**RYE CONSERVATION COMMISSION  
10 CENTRAL ROAD  
RYE, NH 03870**

February 27, 2020

**RE: 381 Sagamore Road, Tax Map 019, Lot 061**

Wetland Sketch Map 1/4-2018

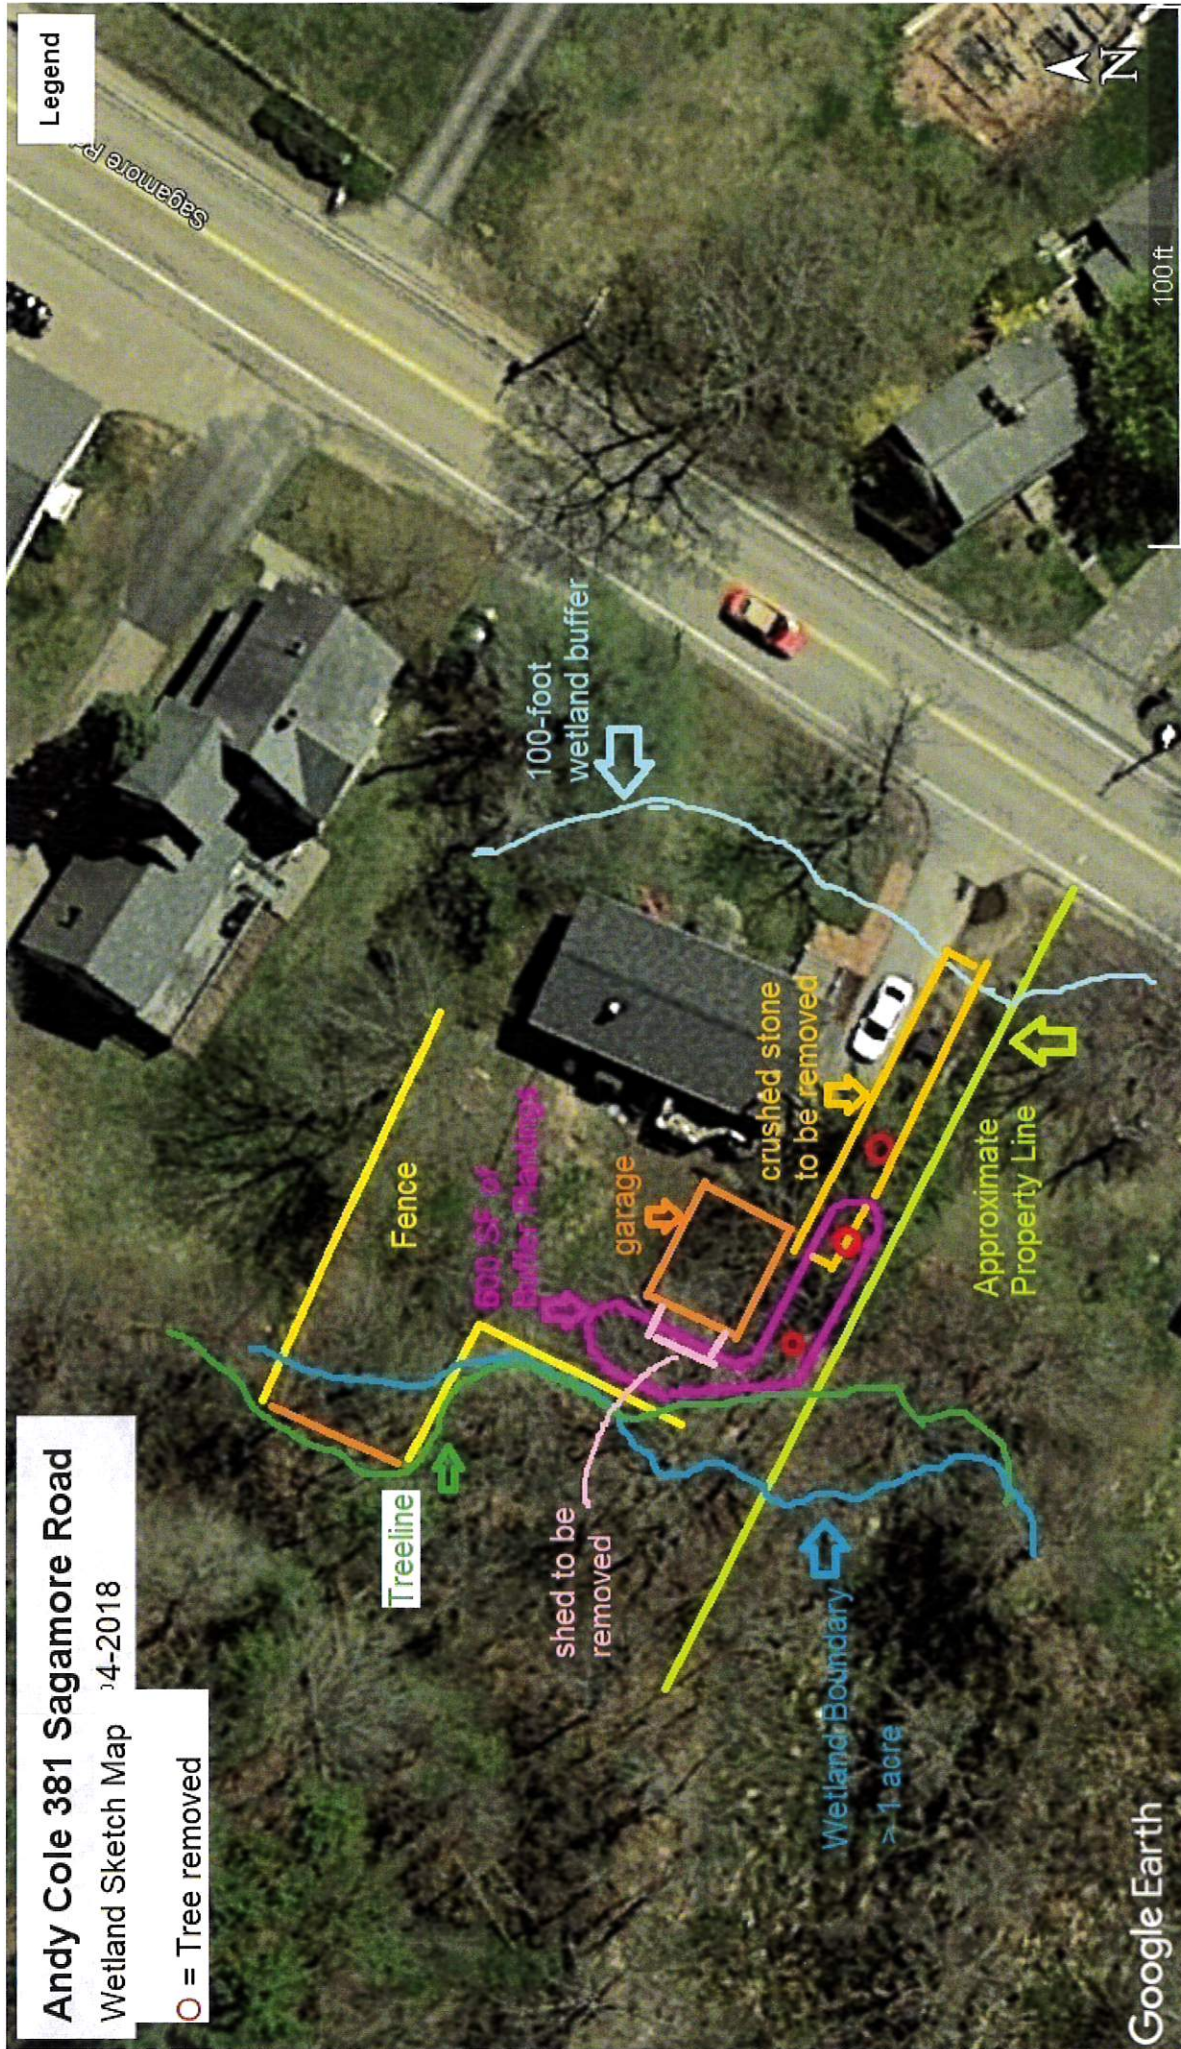
- 1) Dig a dry well within 20-30 ft. of the back of the house and connect the hose from the basement sump pump into the dry well.
- 2) Plant a buffer of native trees and shrubs along the side of the garage even with the edge of the deck, as well as behind the garage along the wetland boundary (which is fenced). The plantings should contain at least 3 oak trees and 3 red maple trees of
